City of Portsmouth Planning Board

Application #: LU-24-151

PROJECT: 100 Borthwick Avenue / 0 Borthwick Avenue, Portsmouth, NH

This letter addresses plan review comments received on September/06/2024 from the City of Portsmouth, NH.

LOT LINE ADJUSTMENT PLAN 2

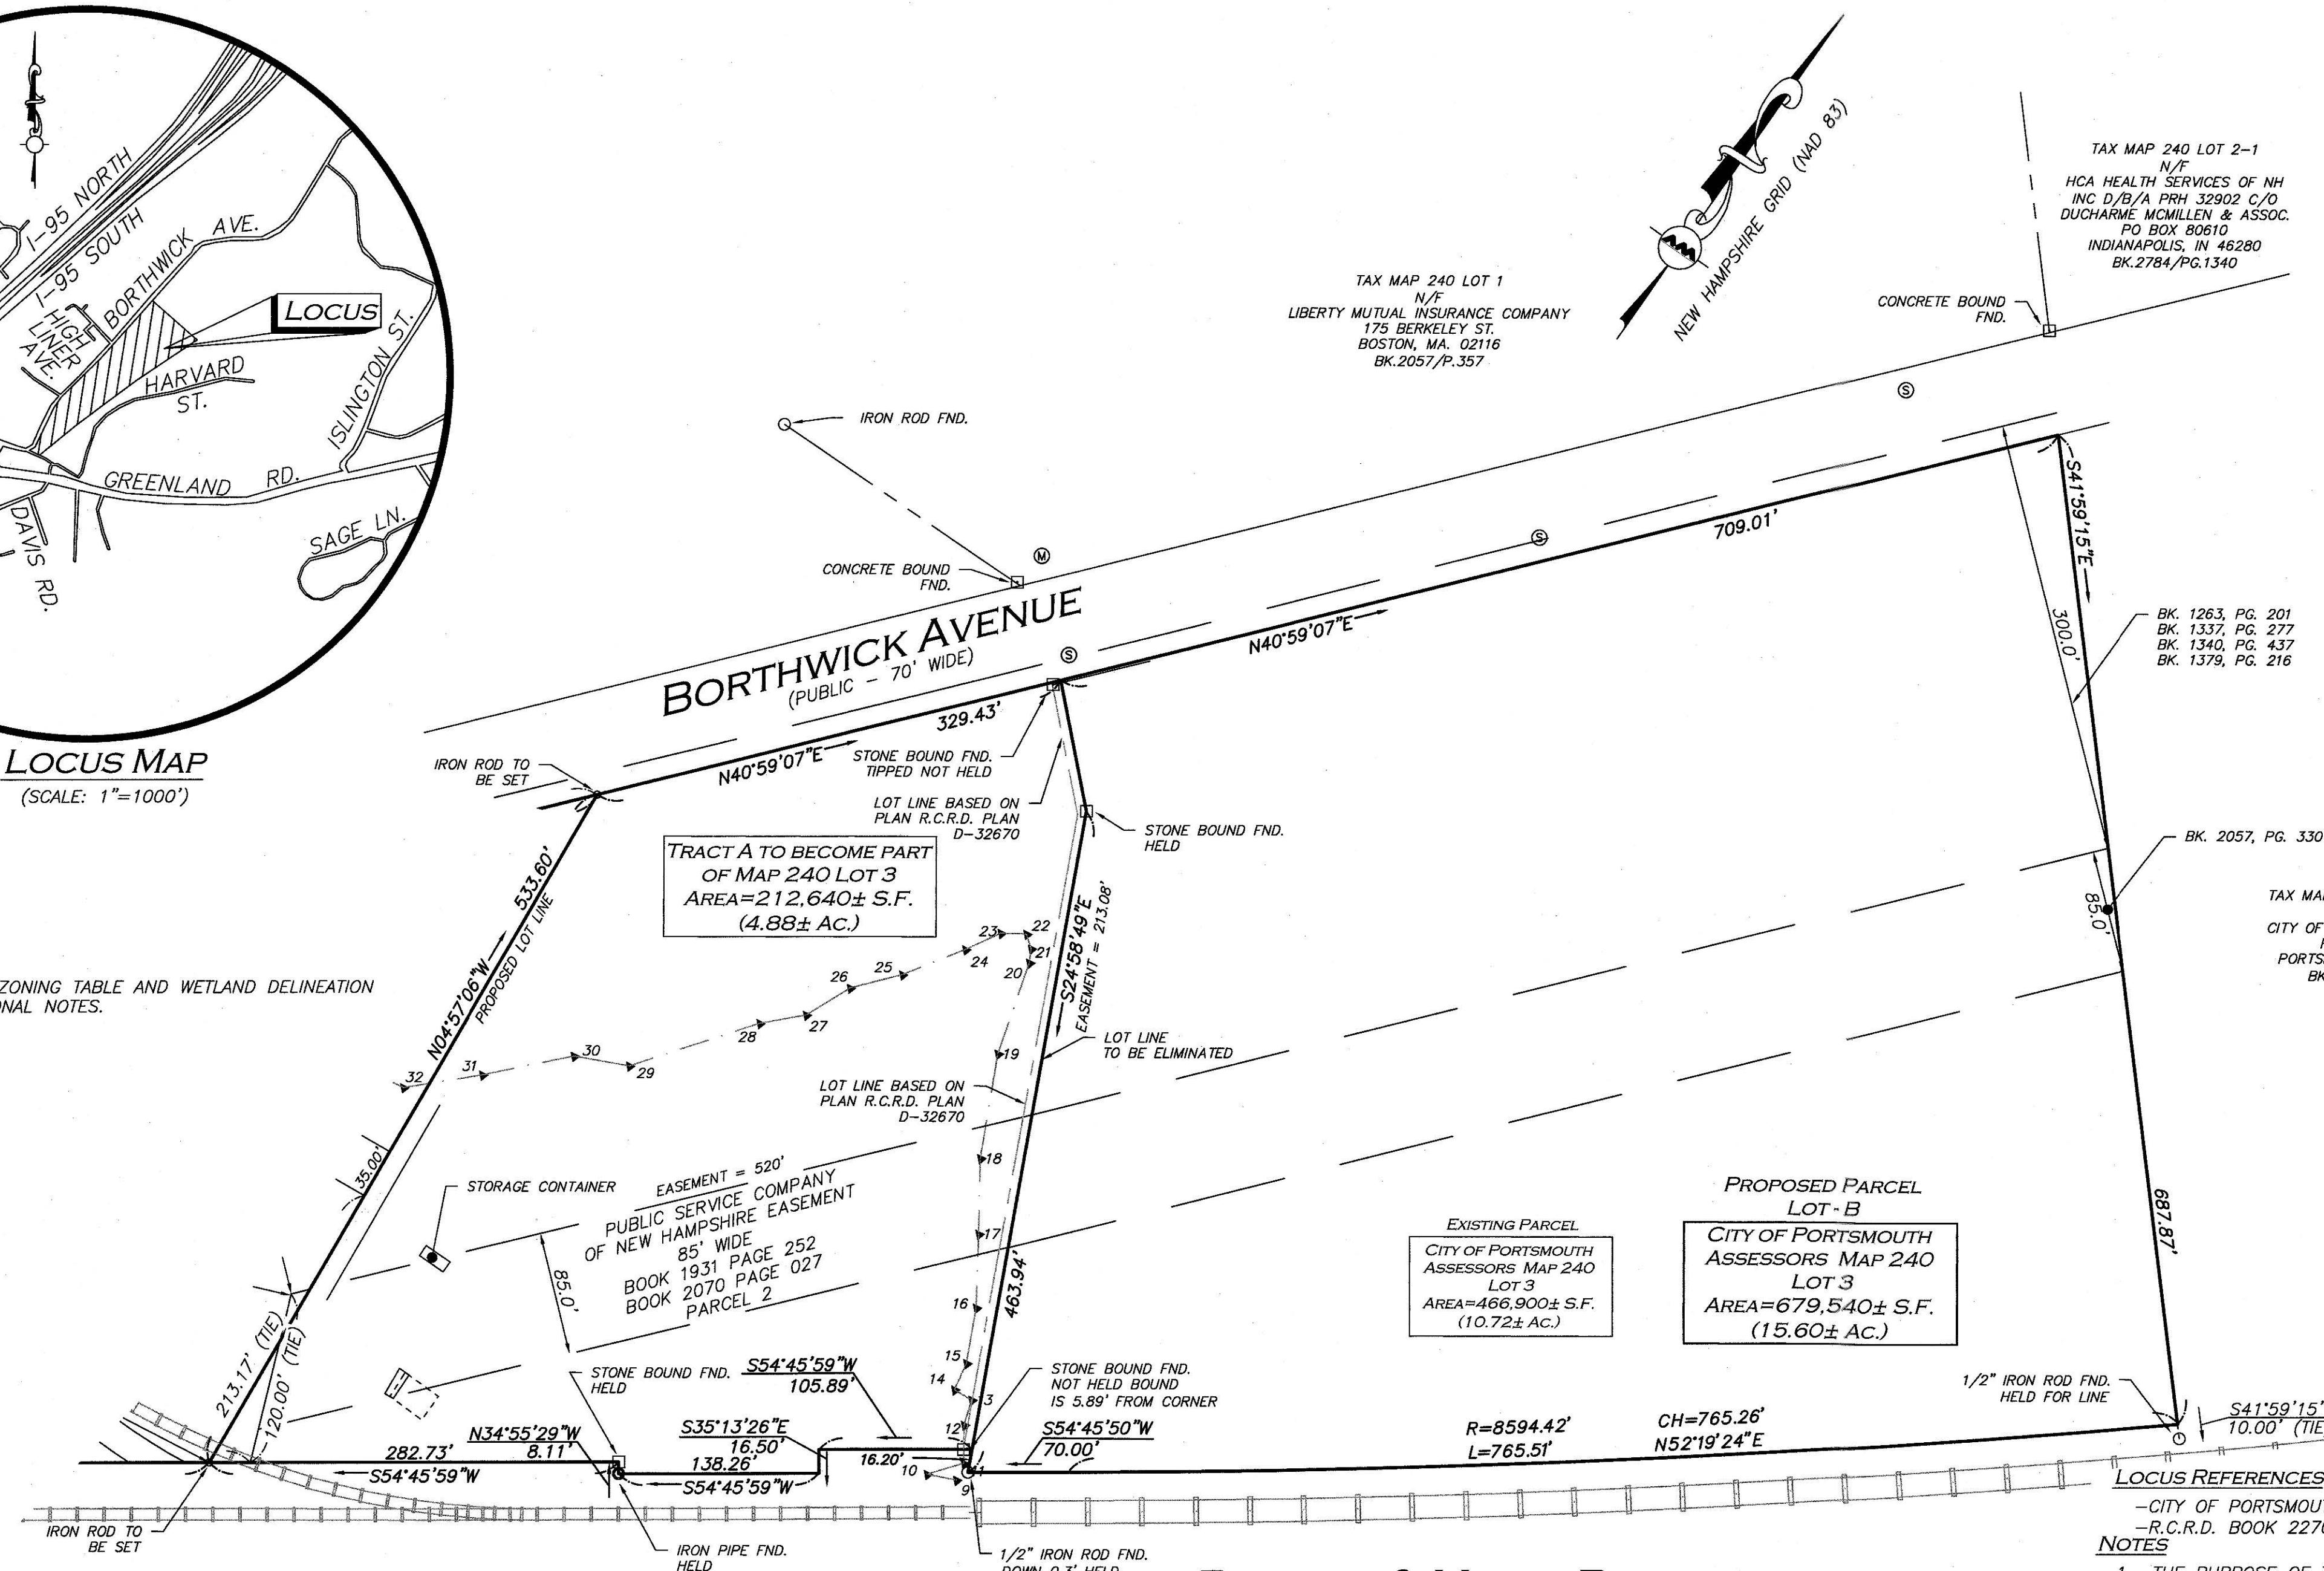
Proposed dimensions for new lots must be included in lot line adjustment plan.

RESPONSE #9: This has been included with submitted documents.

DRAWING TITLE:	SHEET No.
GRADING & DRAINAGE PLAN	C-103

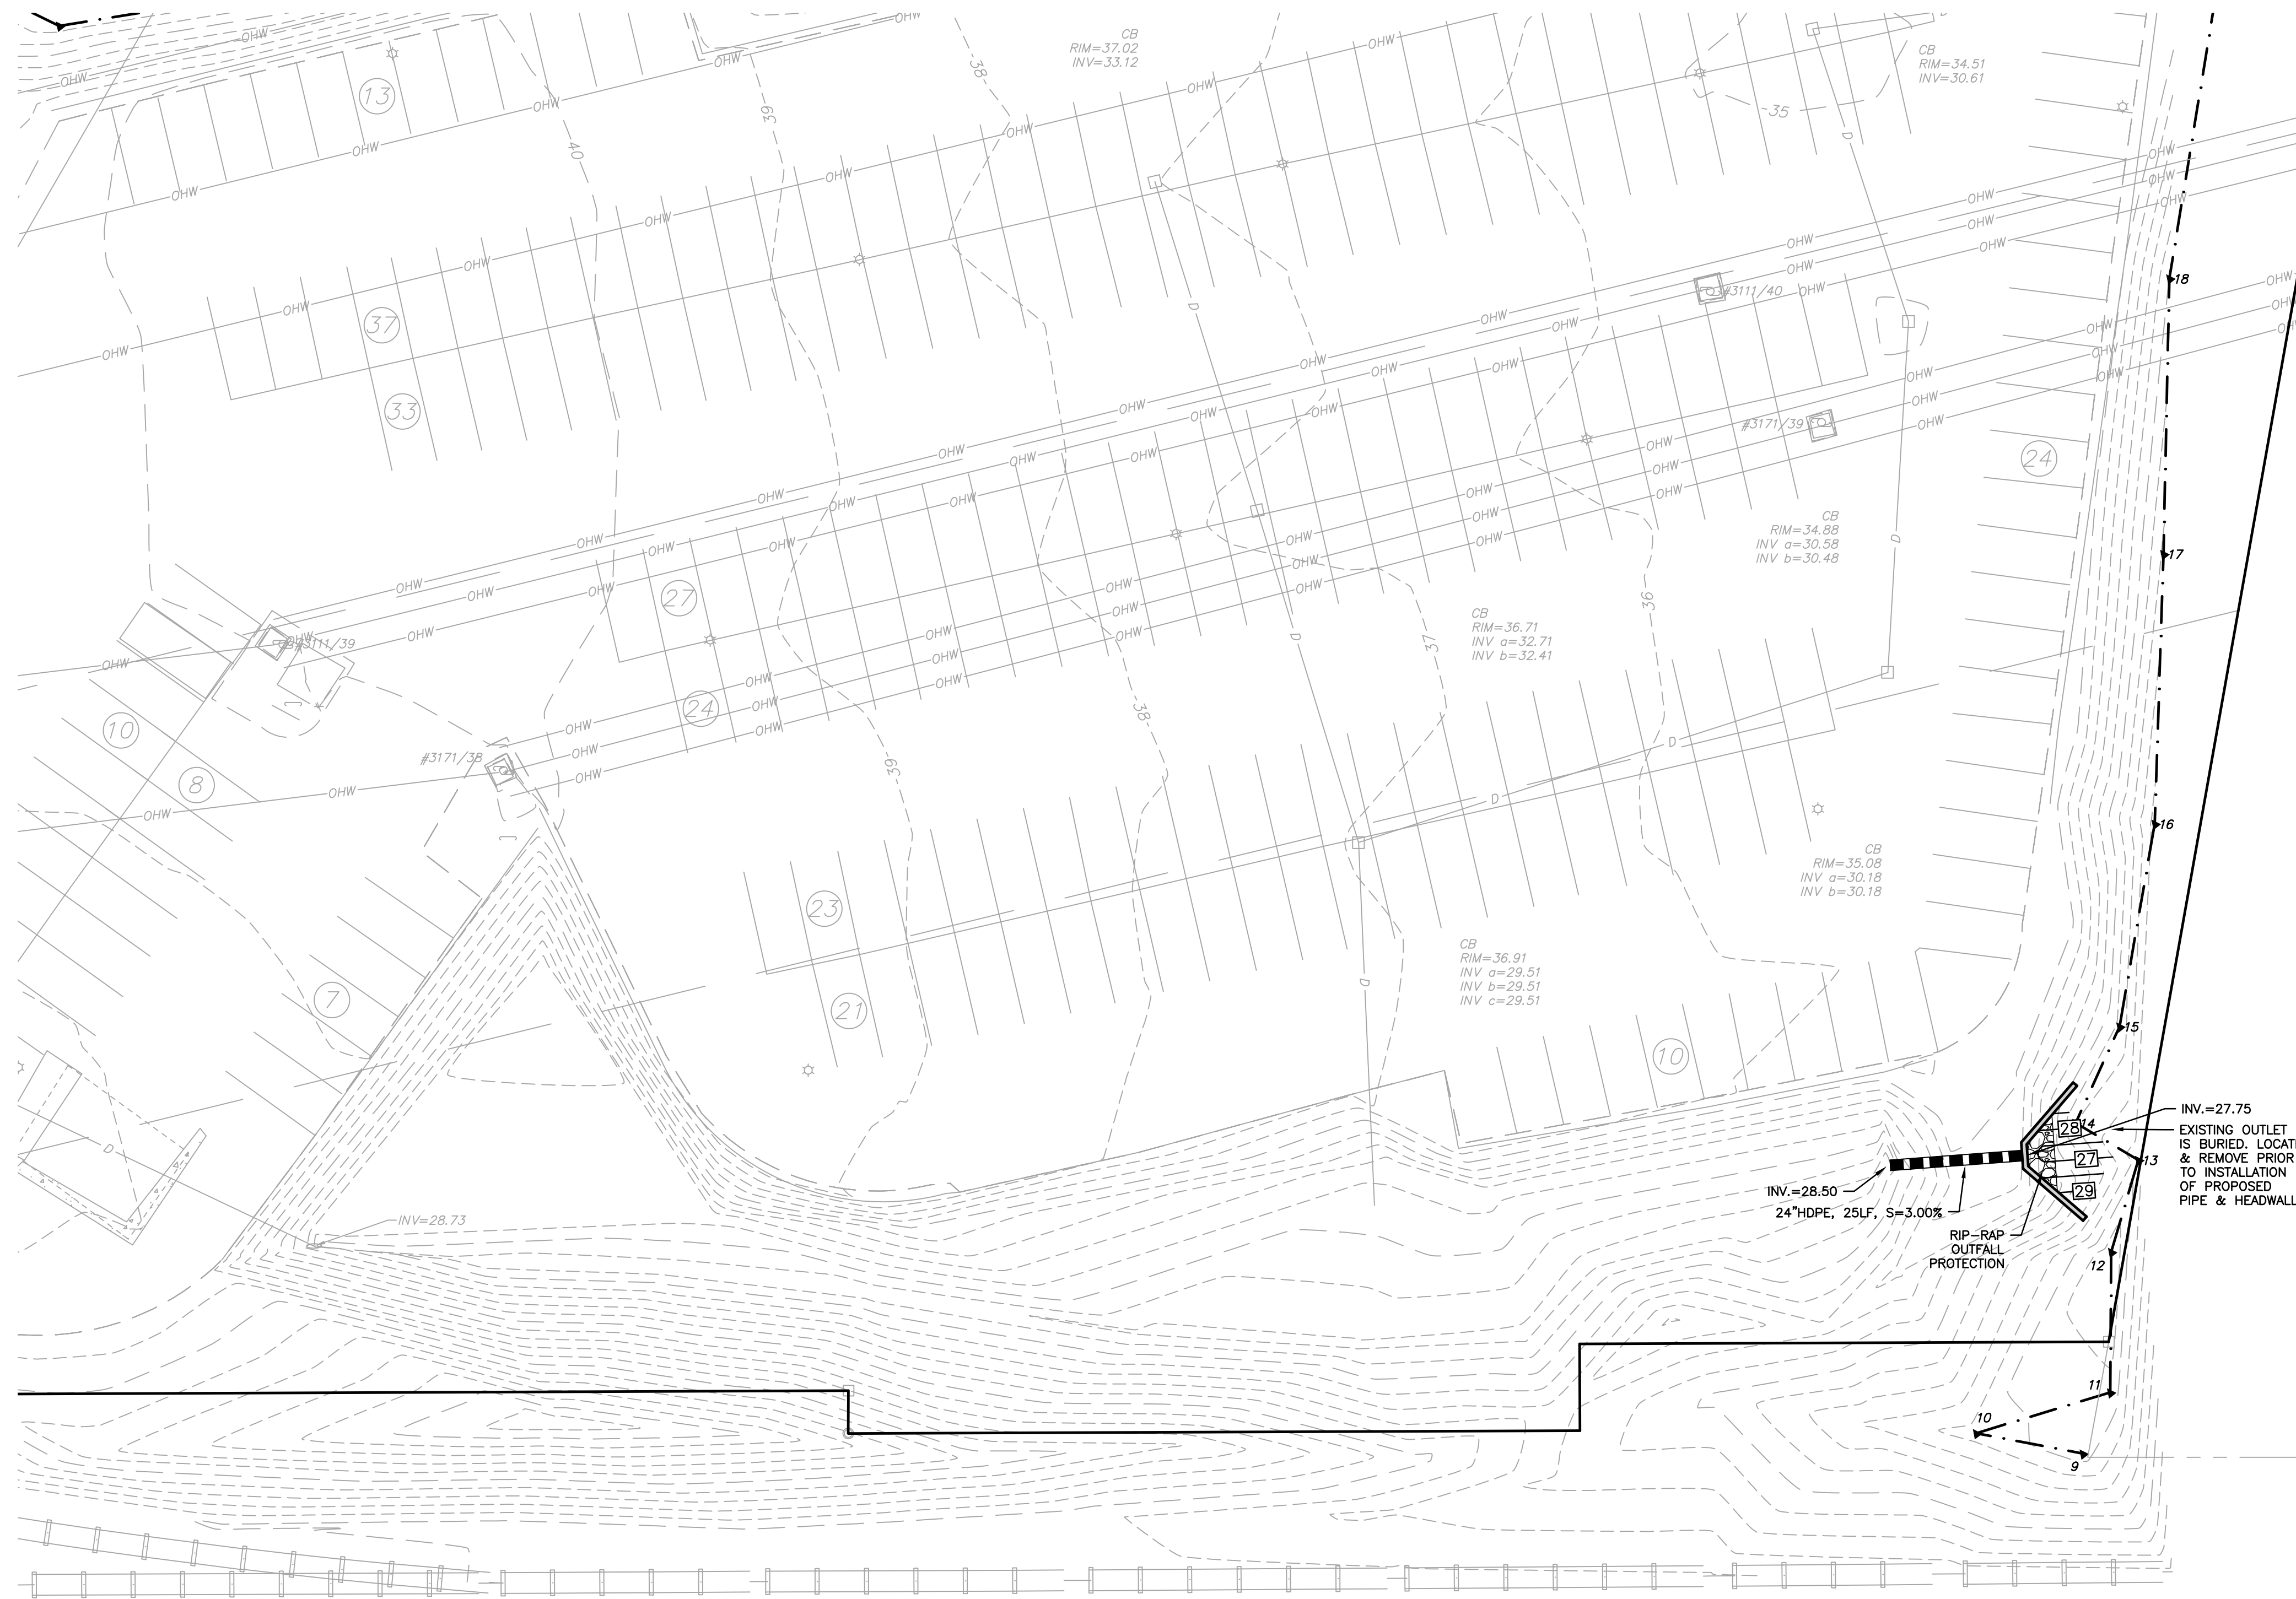
That detention pond no longer meets standards but as minimum I would like to see that it can handle a 50 year storm without overstepping so please run a drainage calculation on that and provide me with results.

RESPONSE #5: We will address with the Planning Board at the November meeting for further clarification.

In conclusion of the proposed analysis, A&M is recommending to remove the existing basin's outlet pipe (it is our understanding it is currently buried) and installing a new 24" HDPE outlet pipe with headwall to handle the amount of runoff reaching this area. This upgrade will ensure the detention basin drains adequately without overtopping for all design storm events.
